Appendix A – IICEP Correspondence

Subject: Online Project Review Request, Tower Project at Wallops Island

Re: Online Project Review Request, Tower Project at Wallops Island, Accomack County, Virginia, Consultation Tracking Number: 05E2VA00-2017-SLI-1157

**ATTACHMENT 1
REVISED FIGURE 1**

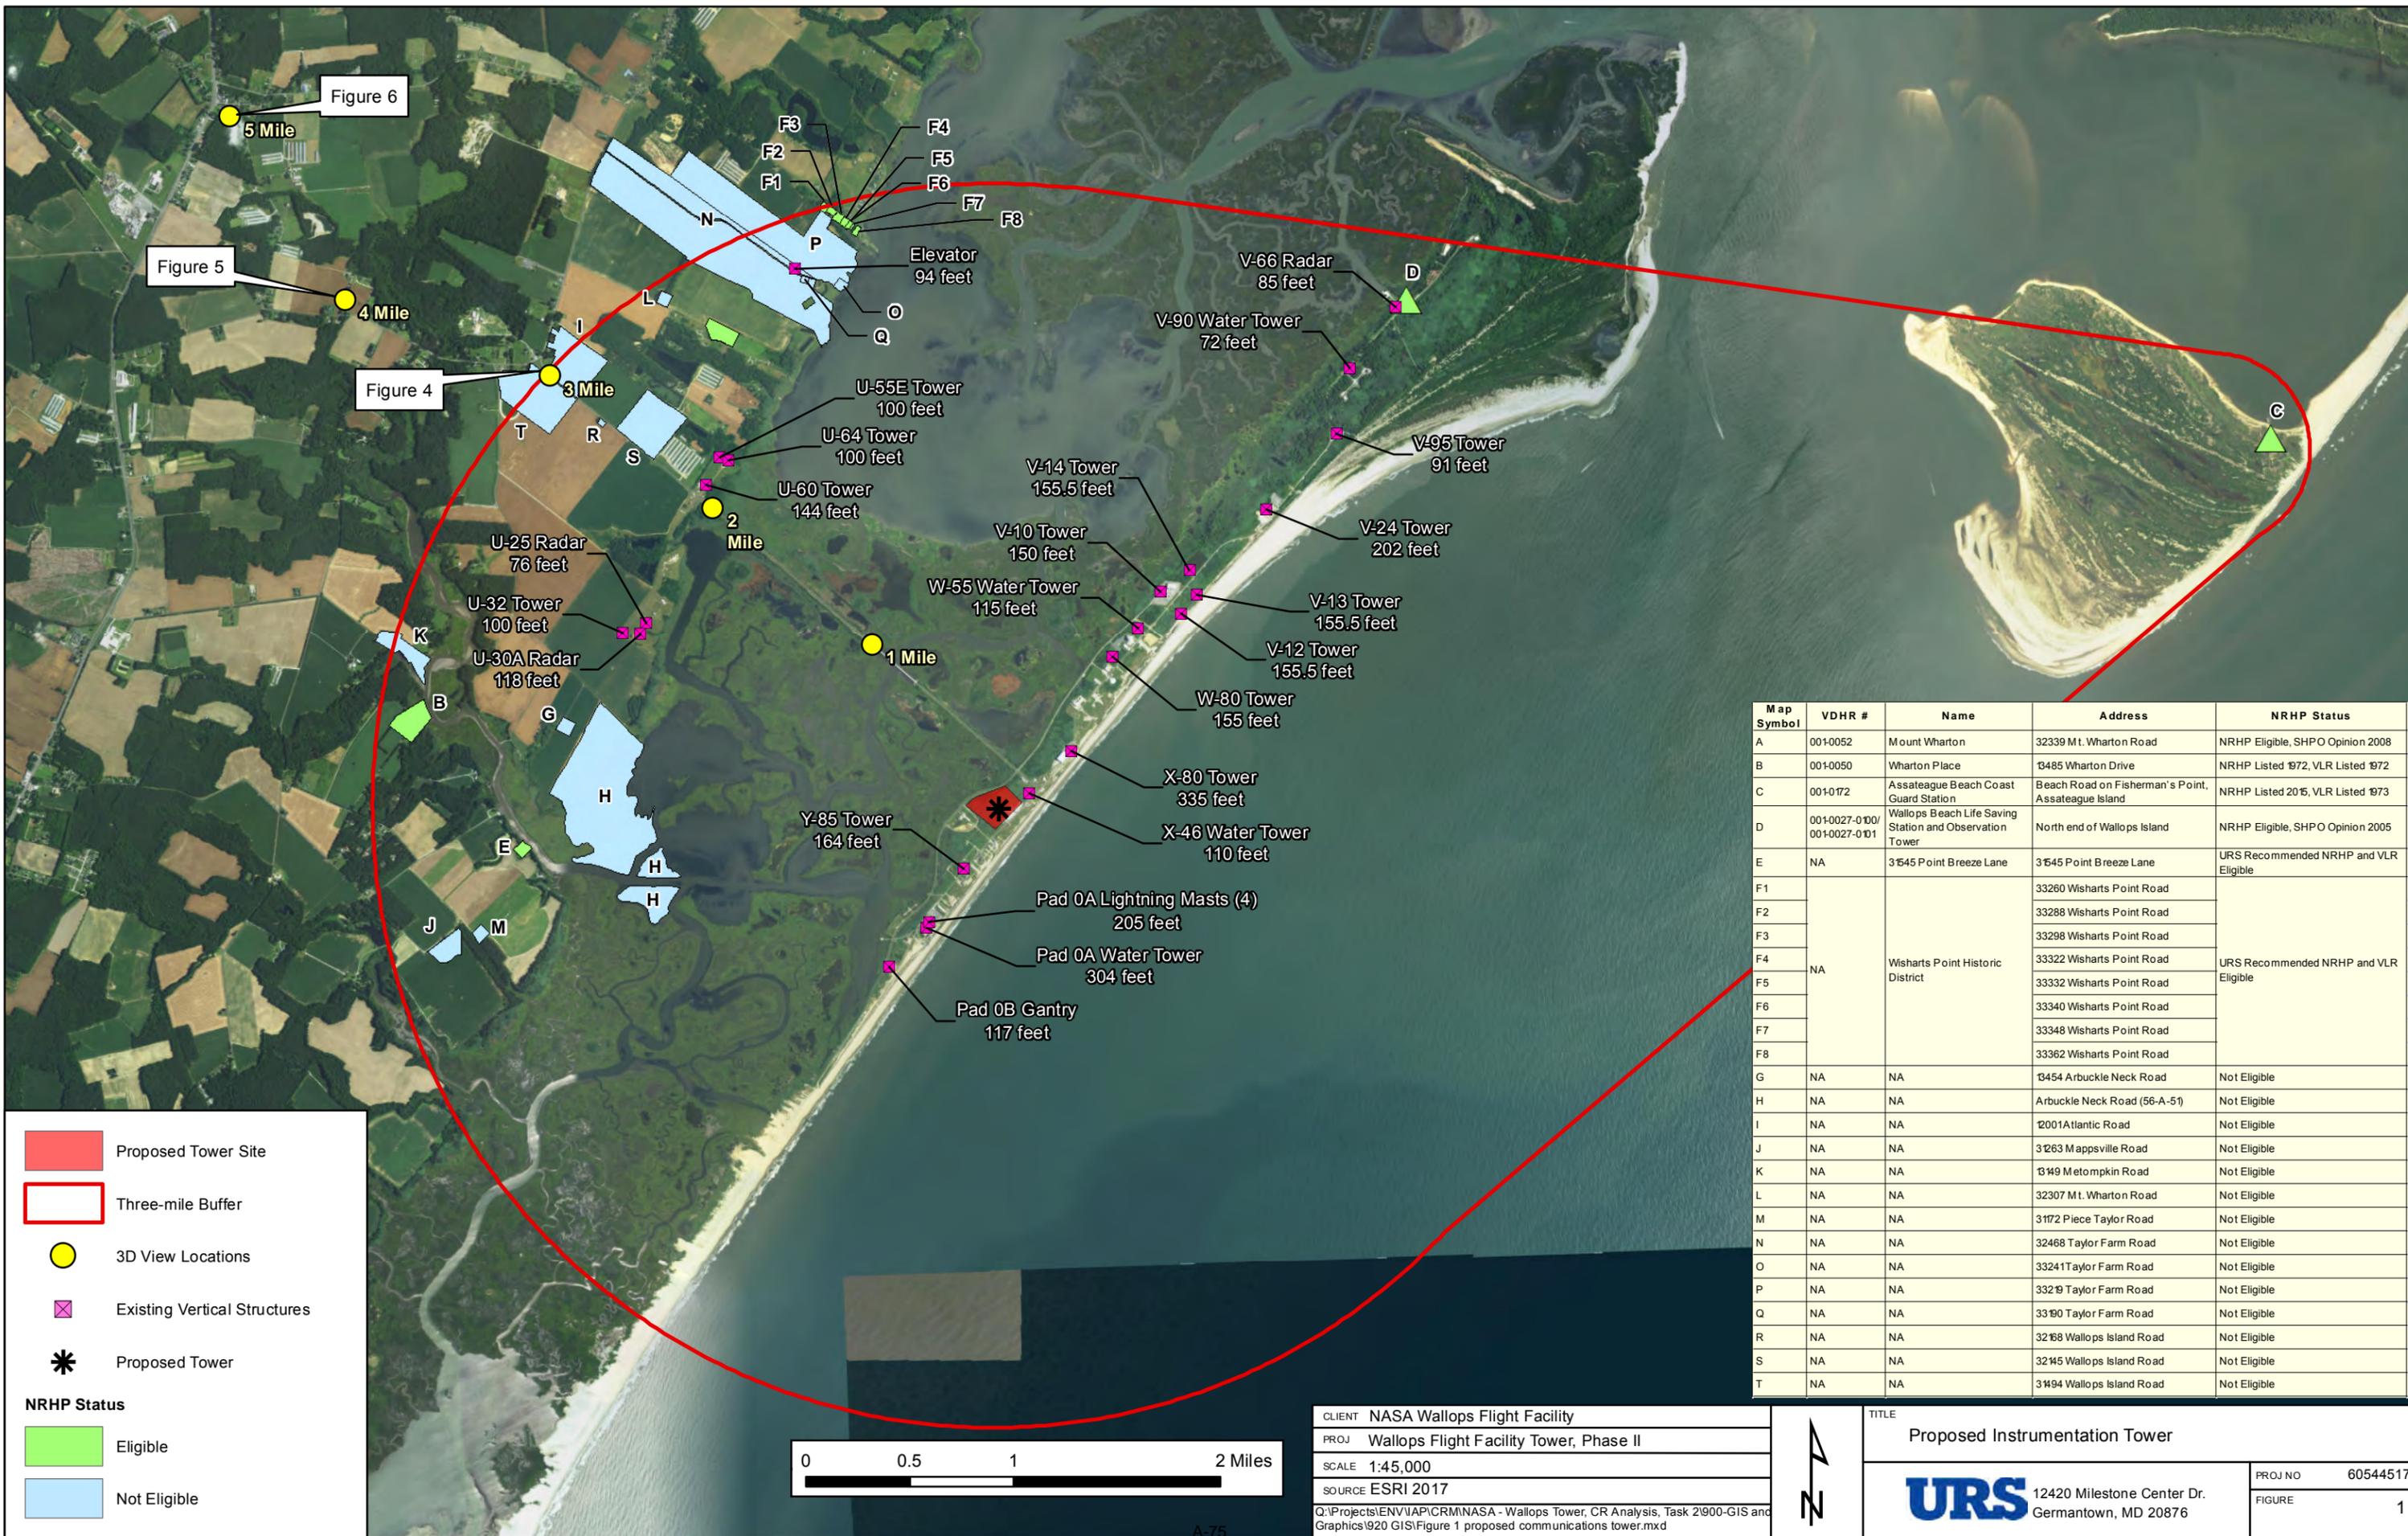
- a. URS Figure 1 points out the location of existing vertical structures that share the coast-line with the proposed tower. Please amend Figure 1 to further identify these keyed items providing their names and total heights.

The Phase II work included: 1) a reconnaissance-level survey following the DHR's *Guidelines for Conducting Historic Resources survey in Virginia*, October 2011; 2) amending Figure 1 (from the prior Phase I report) to further identify the locations, names, and total heights of existing vertical structures that share the coastline with the proposed tower; and 3) representative photographs with visual simulations of the proposed tower geo-located and to scale on the alternative sites to determine if the historic properties' higher surrounding elevations and vegetation would "screen" the proposed tower.

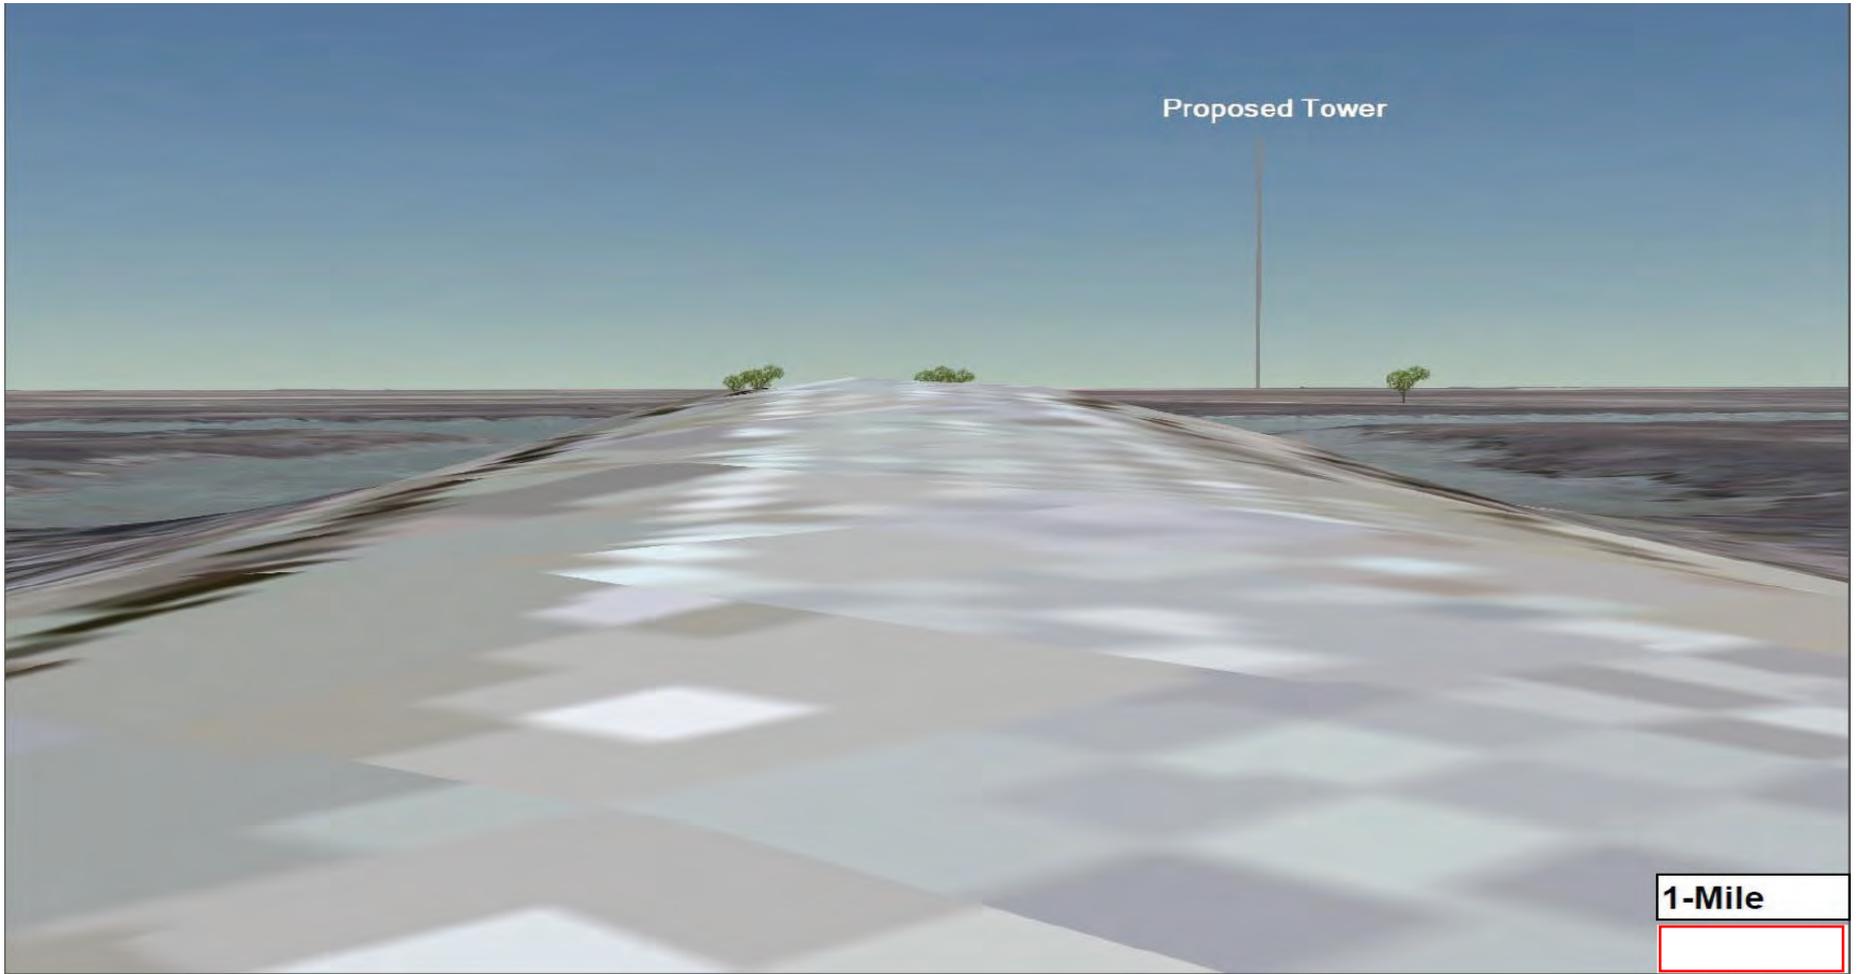
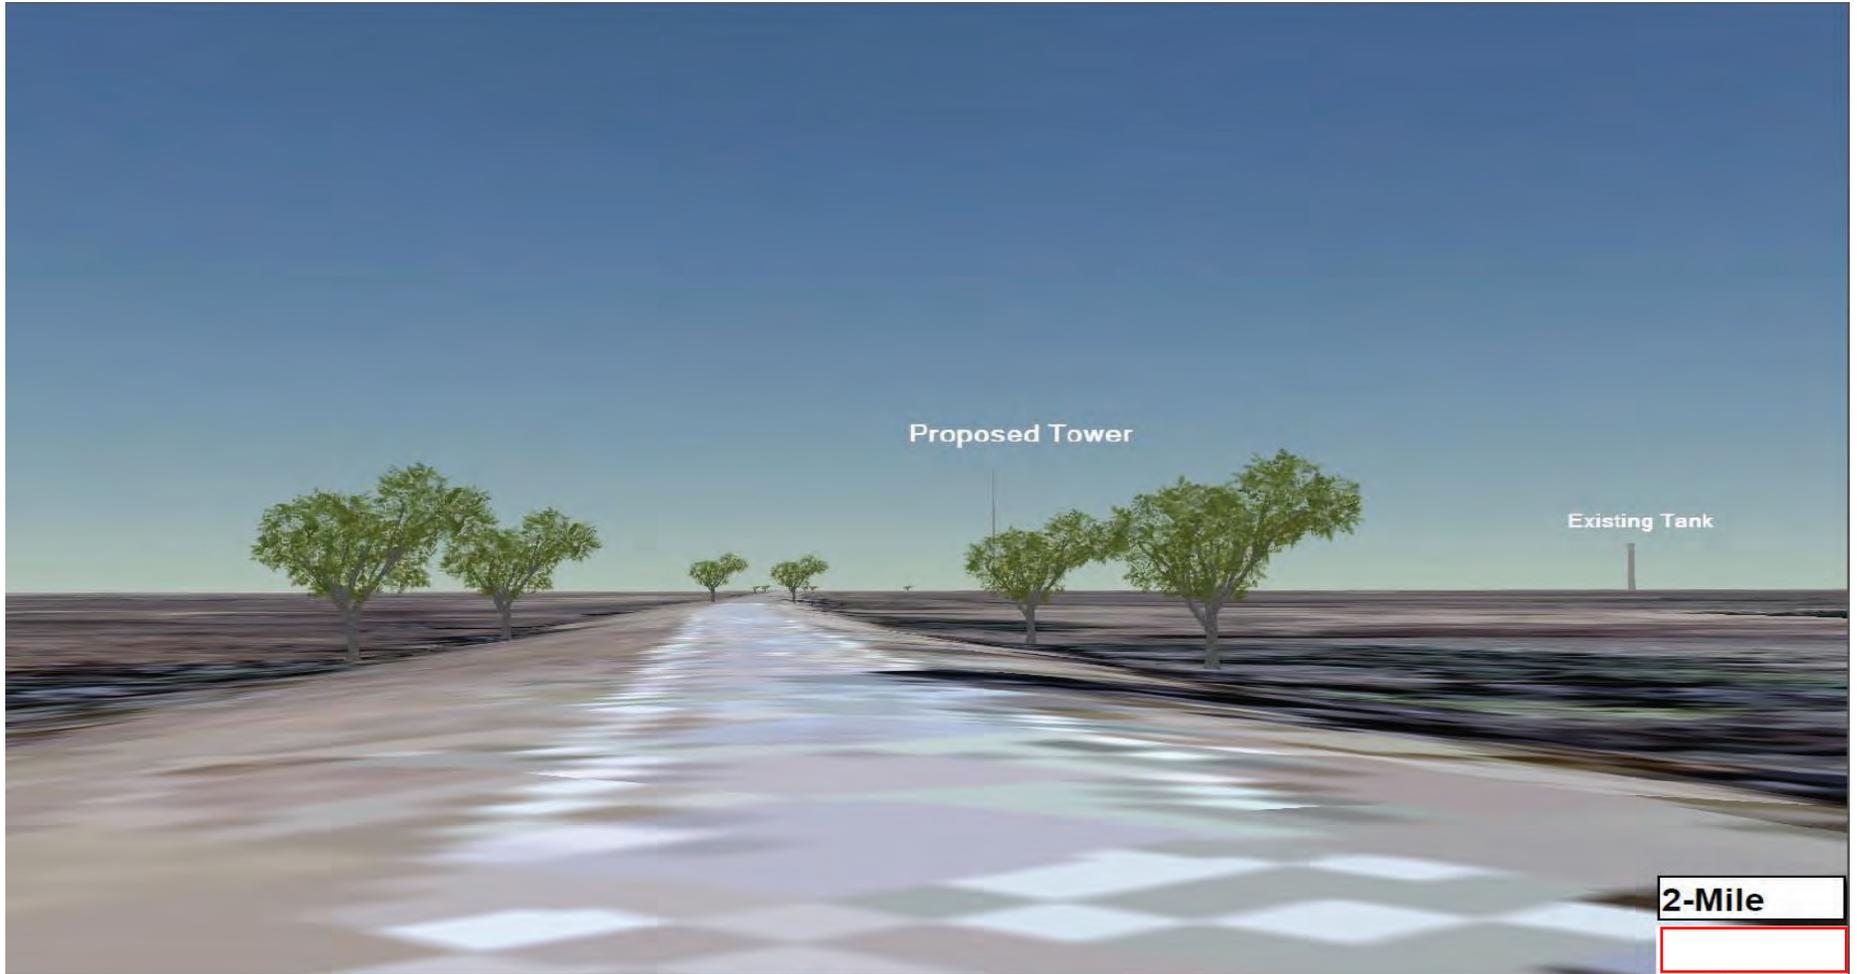
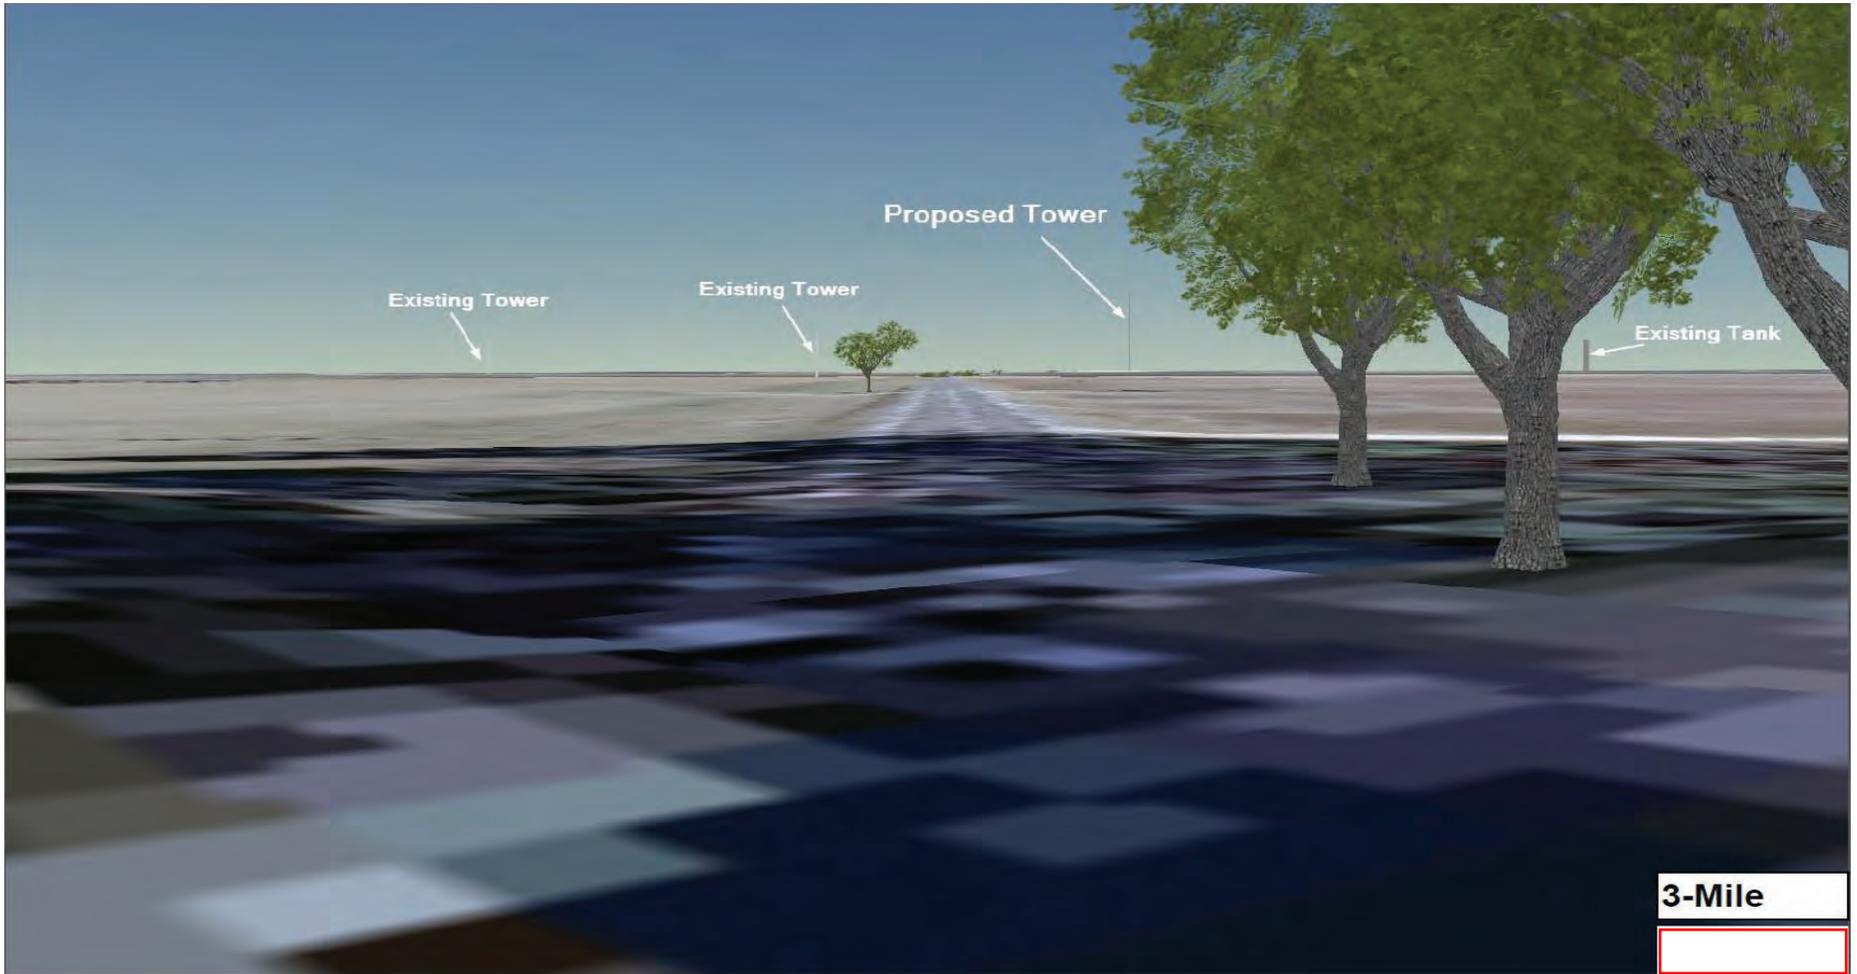
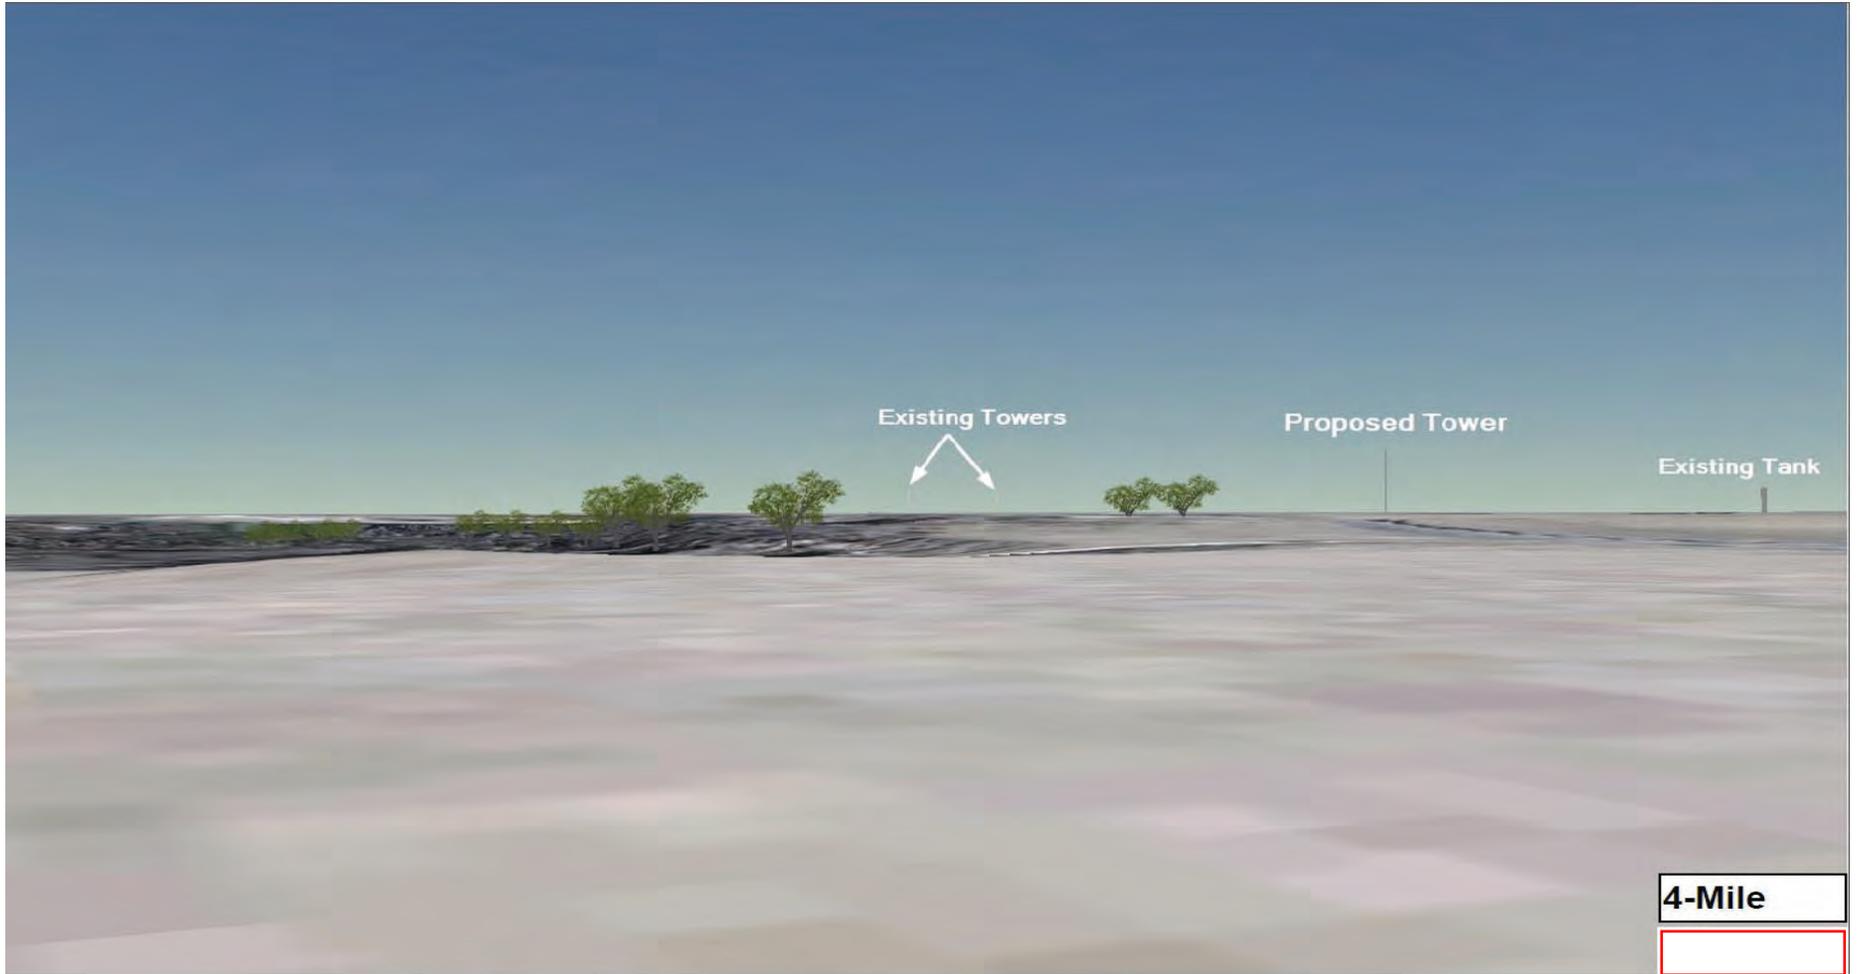
- The photo simulations (Figures 2-6) provided illustrate the visibility of the proposed tower and existing towers and tanks. Unfortunately, the figures are not keyed to Figure 1, which is the proposed APE for indirect effects. Please key Figures 2-6 to Figure 1. Also update Figures 2-6 with captions so that they are easily understood in terms of distance and direction from or towards the proposed tower location.
